**Model:** ES7001

**Subject:** Correction of page 28 of the Service Manual.

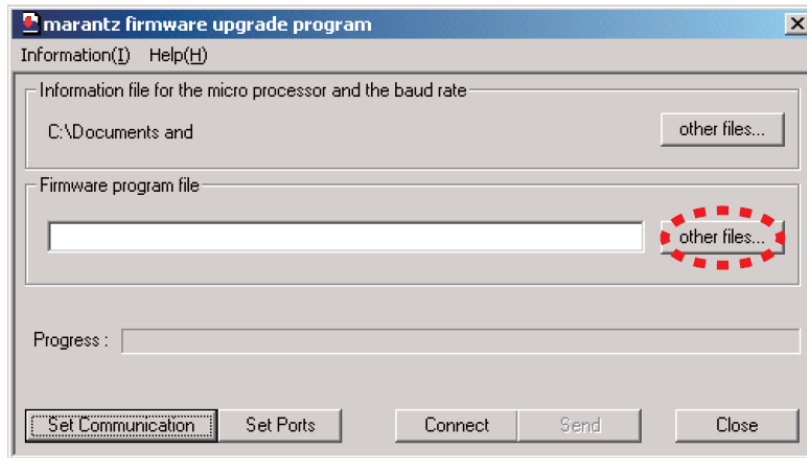
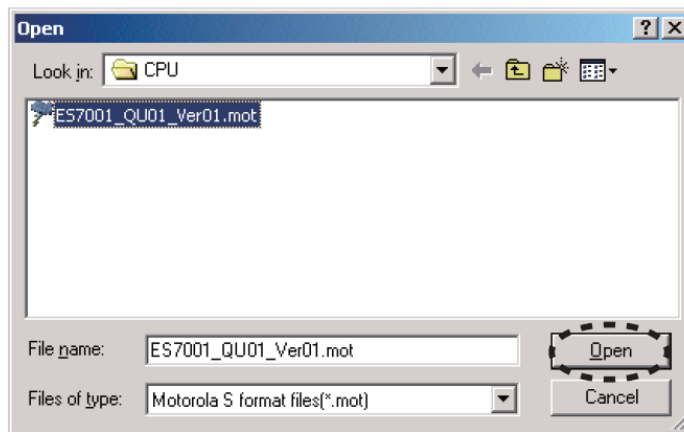
**Symptom:** "Download Firmware for CPU (Mode 3)" mentioned in the ES7001's Service Manual is incorrect.

**Solution:** Download Firmware for CPU (Mode 3)" mentioned on Page 28 of the service manual was changed.

12. Click **other files...** from Firmware program file.

13. Choose **ES7001\_QU01\_Ver1.mot**. And click **Open**.  
**NOTE** : Version number changes whenever software released.
